[1] GREENLINE REVISION 9/30/08
TEDD APPROVAL

STEVENSON ROAD AND MD 129A (BROOKS ROBINSON DRIVE) / I-695 INNER LOOP ON RAMP

TRAFFIC SIGNAL PLAN

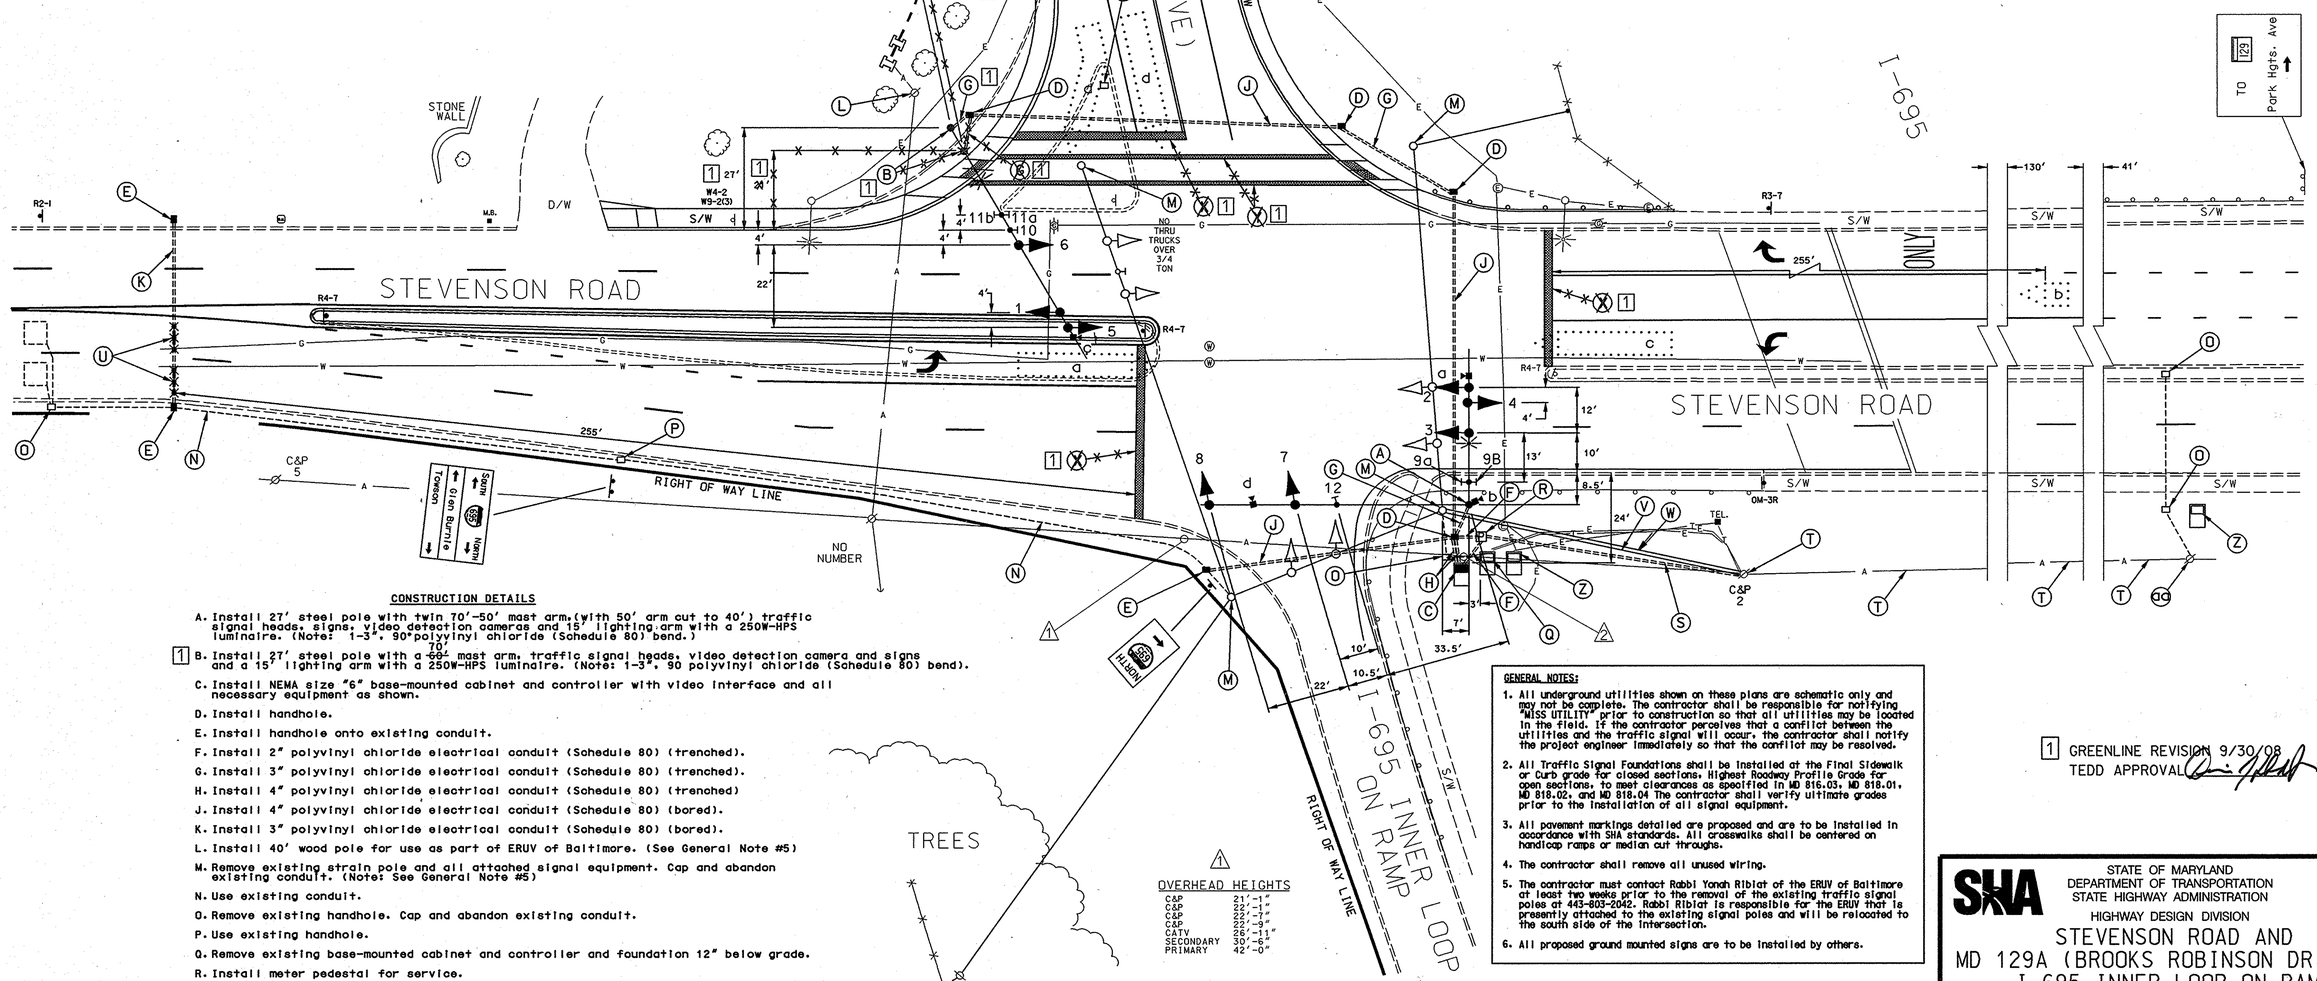
[1] B. Install 27' steel pole with a ~~60'~~ 70' mast arm, traffic signal heads, video detection camera and signs and a 15' lighting arm with a 250W-HPS luminaire. (Note: 1-3", 90 polyvinyl chloride (Schedule 80) bend).

[1] ~~X. Install 24" white heat applied permanent preformed thermoplastic pavement marking (stop line).~~

[1] ~~Y. Install 12" white heat applied permanent preformed thermoplastic pavement marking (crosswalk).~~
